RECALL 23V503 / 2023-402 REMEDY INSTRUCTIONS

Make(s): IMPRESSION
 Model(s): MPF235RW, MPF290VB & MPF330BH
 Model Year(s): 2023

Concern:
 The exterior griddle may be stowed while still connected to LP Gas.

FIGURE 1 - BAD

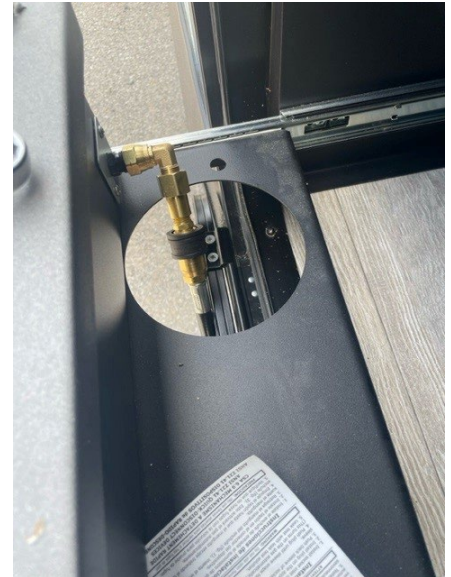
- STEP 1: REMOVE EXTERIOR GRIDDLE FROM VEHICLES EXTERIOR KITCHEN;
- STEP 2: REMOVE BRASS FITTING DEPICTED IN FIGURE 1:
- STEP 3: REMOVE ANY RESIDUAL SEALANT (PASTE OR TAPE) FROM GRIDDLE PIPE FITTING;

PHOTO LOOKING DOWN ONTO GRIDDLE (GRIDDLE TOP IS UPSIDE DOWN)
 THIS SHOWS THE LP GAS HOSE CONNECTED BUT ALLOWS THE GRIDDLE TO STOW AWAY WHICH IS BAD.

- STEP 4: APPLY NEW SEALANT RATED FOR LP GAS TO THE GRIDDLES PIPE FITTING;
- STEP 5: THREAD ON THE 90° BRASS FITTING ASSEMBLY AT AN ANGLE AS DEPICTED IN FIGURE 2;

PHOTO LOOKING DOWN ONTO GRIDDLE (GRIDDLE TOP IS UPSIDE DOWN)
 THIS SHOWS THE LP GAS HOSE CONNECTED BUT DOES NOT ALLOW THE GRIDDLE TO STOW AWAY.
